Gas cylinders — Cylinder valves — Specification and type testing

AMENDMENT 1: Pressure drums and tubes

Reference number
ISO 10297:2014/Amd.1:2017(E)

Figure F.1 — Typical arrangement of a computer controlled test machine

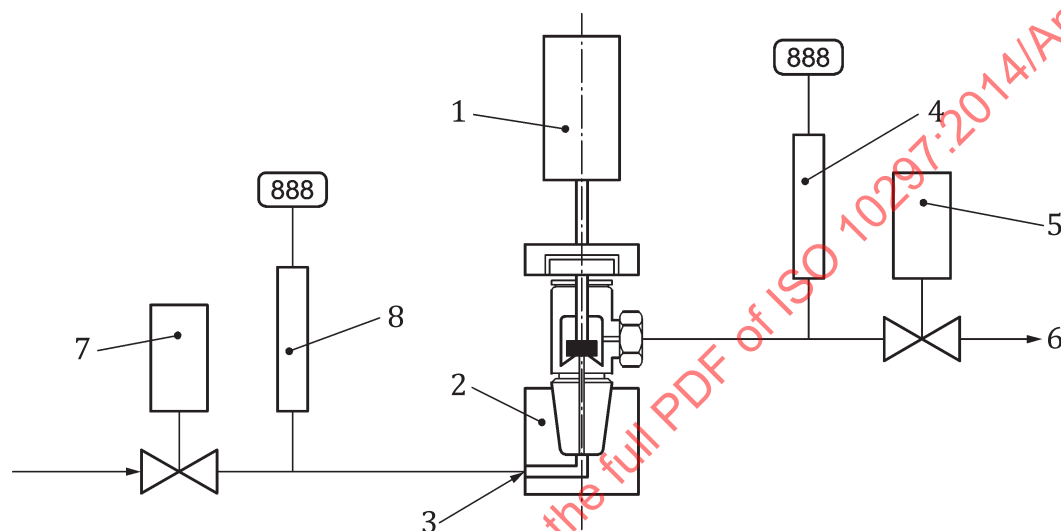
F.1, figure

Delete “a” and “b” from the figure and the key.

Replace Figure F.1 with the following:

- 1 DC motor with torque transmitter
- 2 test sample with adapter
- 3 input test medium
- 4 high pressure transducer with display
- 5 venting valve
- 6 outlet
- 7 valve
- 8 inlet high pressure transducer with display for monitoring of p_{vt}
